# A d d e n d u m

Iowa Department of Transportation  
Office of Contracts

<b>B.O.</b>	<b>Proposal ID</b>	<b>Proposal Work Type</b>	<b>County</b>	<b>Project Number</b>	<b>Addendum</b>
004	20-0352-300-A	BRIDGE REPLACEMENT - STEEL GIRDER	CLARKE	BRFIMX-035-2(296)37--14-20 BRFIMX-035-2(300)39--14-20	18SEP004.A01

SPECIAL PROVISIONS FOR LRFD PILE DESIGN AND PLANNED RETAPS

PILE RE-TAP PLAN

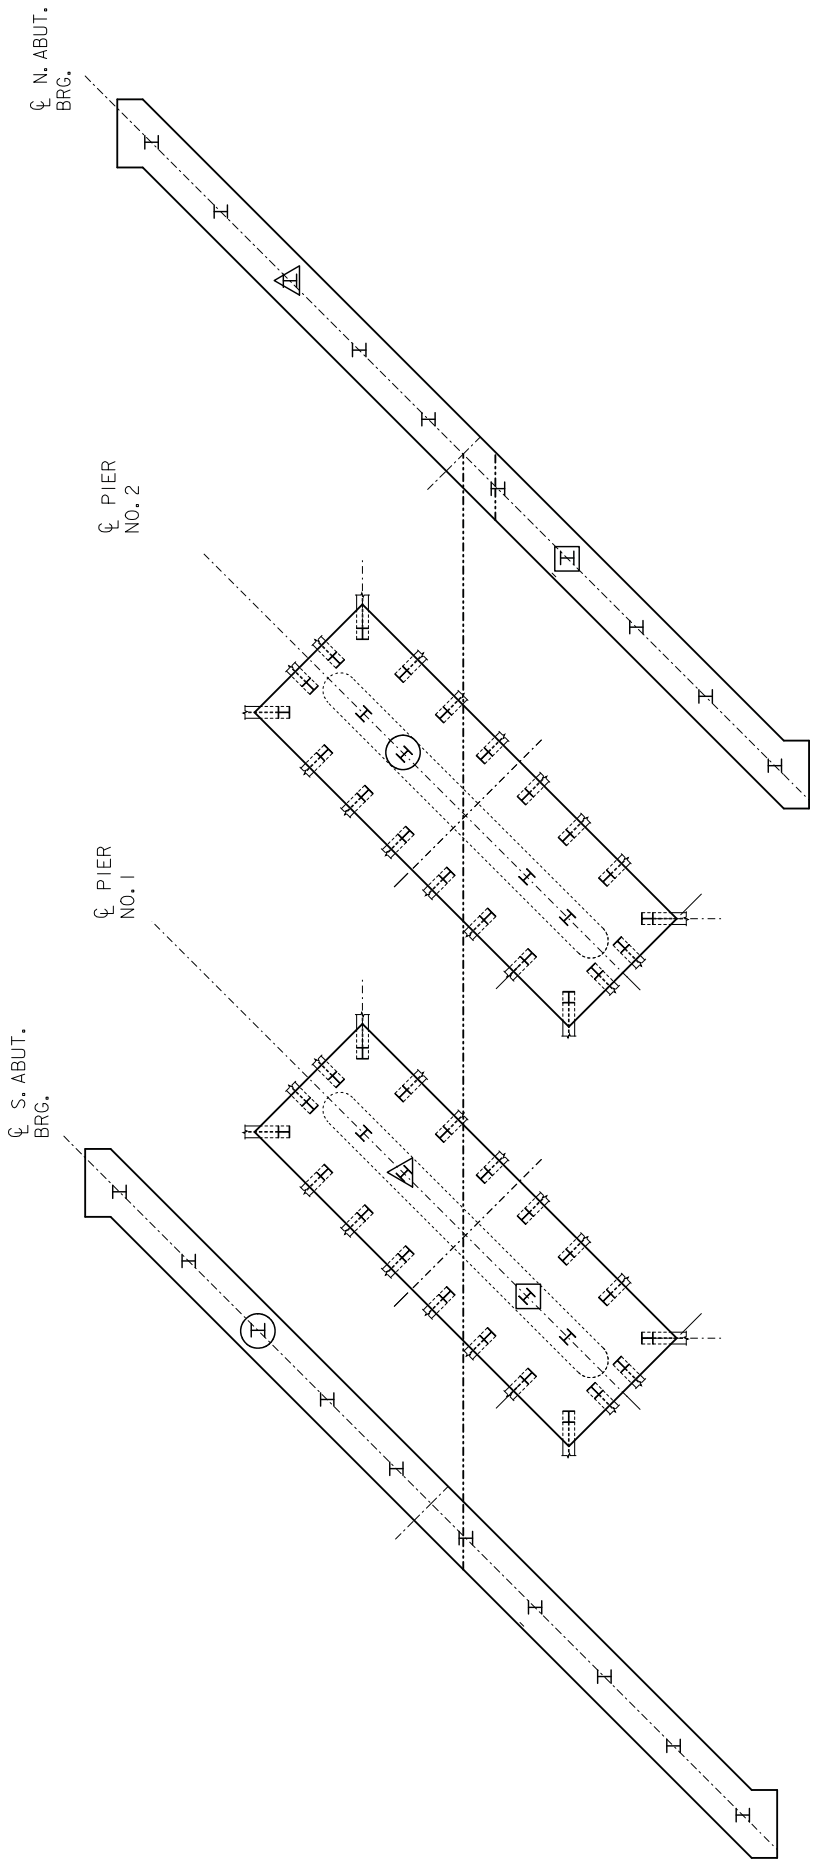
Make the following change to plan sheet number 3:

Attach 'Pile Re-Tap Plan'.

- = 1 DAY RE-TAP ONLY
- = 1, 3, & 7 DAY RE-TAPS
- △ = 7 DAY RE-TAP ONLY
